# SERVICE LETTER

No. 956

Piper Aircraft Corporation

Cabin Door Cable Assembly Inspection and  
Modification

SKETCH "A"REF. S. L. 956

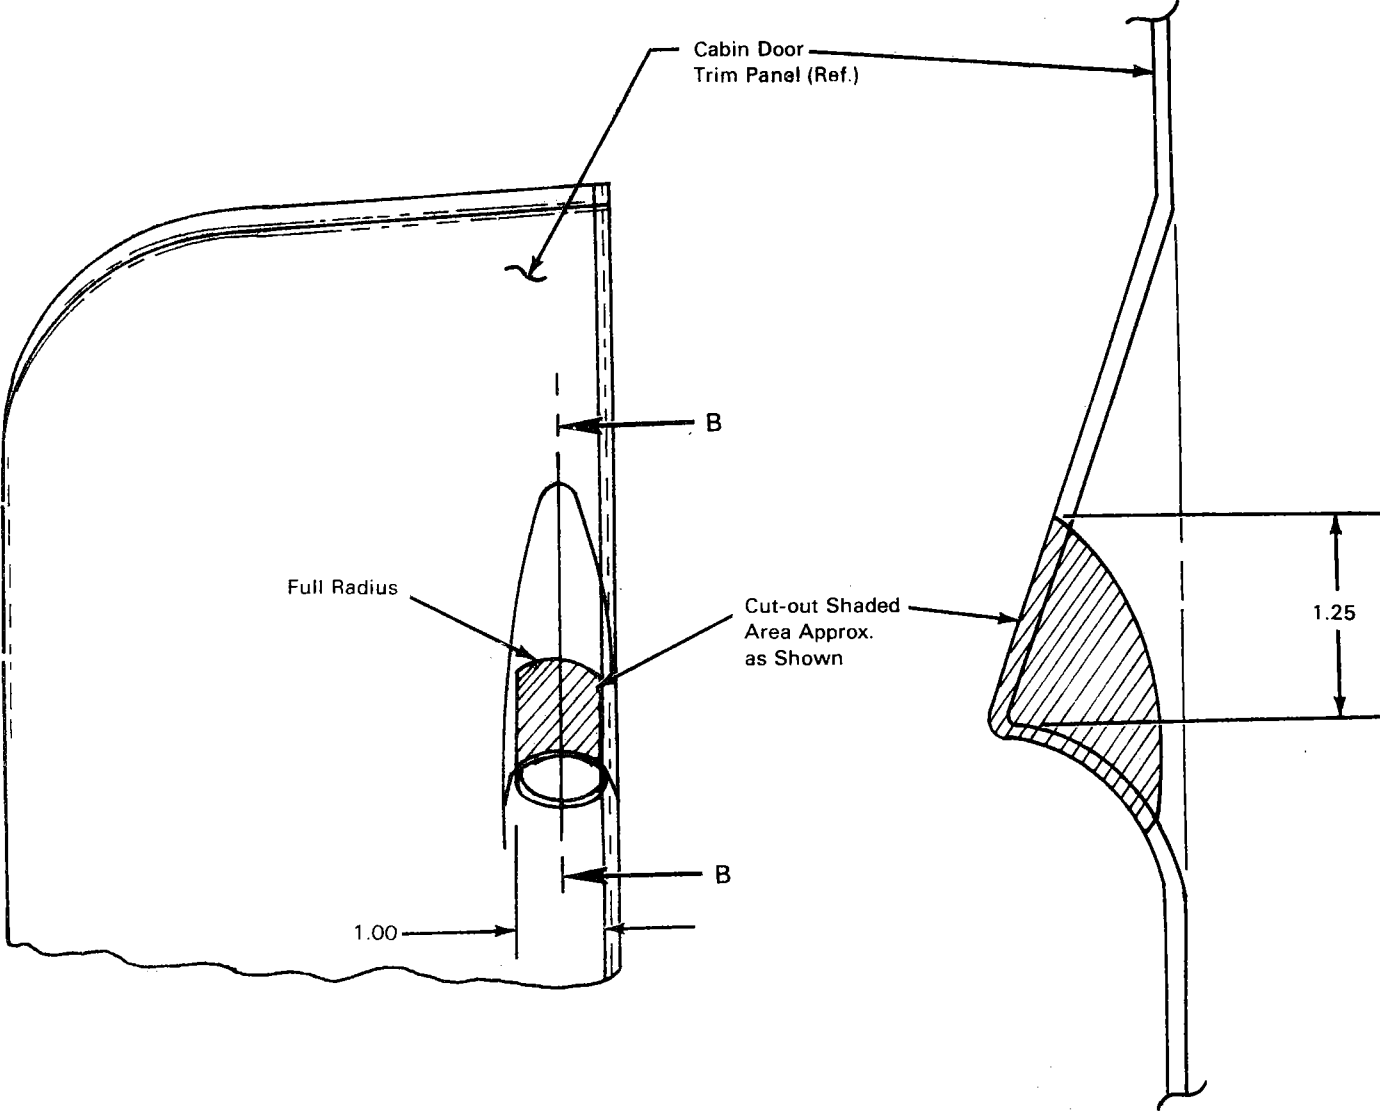
Field reports have been received of the aft cabin door support cable end fitting breaking where it screws into the lower rod end bearing. When the cable is pulled forward or rearward, the channel (Part Number 49129-02) restricts the rod end bearing movement, sometimes causing the cable end to bend and, possibly, break.

This Service Release provides instructions for inspection of cables and for removal of the Channel, Part Number 49129-02, to prevent the possible damage to the aft door support cables.

1. Pull back the lower boot assembly on the aft door support cable.
2. Secure the bolthead, and unscrew the nut from the bolt fastening the cable's rod end bearing to the door support bracket. Remove and discard the Part Number 49129-02 Channel (Refer to Sketch A).
3. Remove the rod end bearing and inspect the cable end. Replace the cable assembly if the cable end is found to be bent or cracked.
4. Modify cabin door trim panel in accordance with Sketch B.
5. Reinstall rod end, attach cable to door and adjust to proper length.
6. Make appropriate logbook entry of compliance.
